UNITED STATES
NUCLEAR REGULATORY COMMISSION
WASHINGTON, D. C. 20555

SUBJECT: IE NOTICE REGARDING MAIN STEAM SAFETY
VALVE TEST FAILURES AT WYLE LABORATORIES

IE Information Notice No.: 85-xx MAIN STEAM SAFETY VALVE TEST FAILURES AND RING SETTING ADJUSTMENTS

FIG. 1

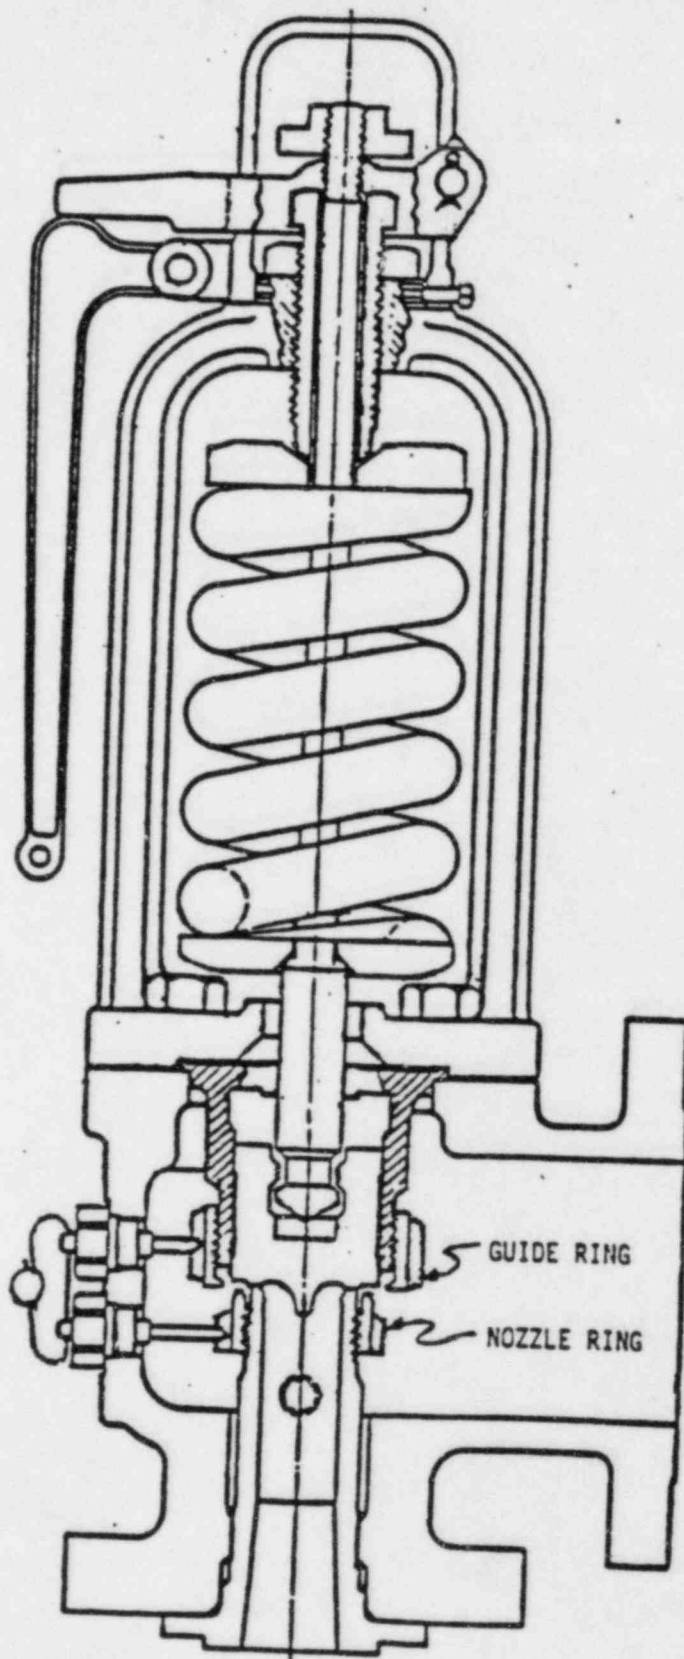
This Information Notice is being provided as a notification of a potentially significant problem pertaining to spring-actuated main steam safety valves (See Figure 1), that may possess less than the full rated flow capacity required for overpressure protection of the secondary cooling system in PWRs. It is expected that recipients will review the information for applicability to their facilities and consider actions, if appropriate, to preclude a similar problem at their facilities. However, suggestions contained in this Information Notice do not constitute NRC requirements; therefore, no specific action or written response is required.

Between October 16, 1984, and December 1, 1984, Wyle Laboratories conducted several full flow steam tests on two separate main steam safety valves (MSSVs) manufactured by Crosby Valve and Gage Company. These Crosby 6R10 MSSVs are to be installed by Public Service of New Hampshire on the Seabrook main steam system. The tests were conducted in order to determine the adequacy of various MSSV discharge piping arrangements. During the tests the valves were instrumented to measure valve disk lift. The valves were installed on the test facility with the settings of the valve adjusting rings (see Figure 1) as received from the valve vendor. With these ring settings the valve achieved about 50% of the full disk lift required to develop full steam flow capacity within the American Society of Mechanical Engineers (ASME) Boiler and Pressure Vessel Code required 3% accumulated overpressure limit. Adequate lift was not achieved for either valve with these factory adjusted ring settings, even for the largest diameter (least flow resistance) vent pipe tested. The guide ring of both valves was subsequently adjusted to a lower position by a significant amount (150 notches) during the course of testing and full disk lift was subsequently achieved.

These types of full flow tests are not normally performed by either reactor owners or the valve vendor on MSSVs, nor are such tests required for capacity certification according to the ASME Code, Section III. In general, these valves are capacity certified by tests on much smaller size valves, and the capacities then extrapolated to larger size valves. The MSSVs on most PWRs, while not necessarily the same model or supplied by the same vendor, are like those at Seabrook in that they are generally at the upper end of the valve size range. This raises the concern that full flow functional demonstration of some valve types may never have been performed, and that due to incorrect ring settings, the valve may not be capable of providing relief capacity in accordance with facility design requirements.

Based on the full flow tests performed at Wyle Laboratories, Public Service Company of New Hampshire (PSCNH) has concluded that the guide ring setting for the Seabrook MSSVs should be adjusted downward 150 notches to ensure full flow capacity. The MSSVs will be installed at Seabrook with the guide ring adjusted downward 150 notches from the as delivered, factory adjusted setting.
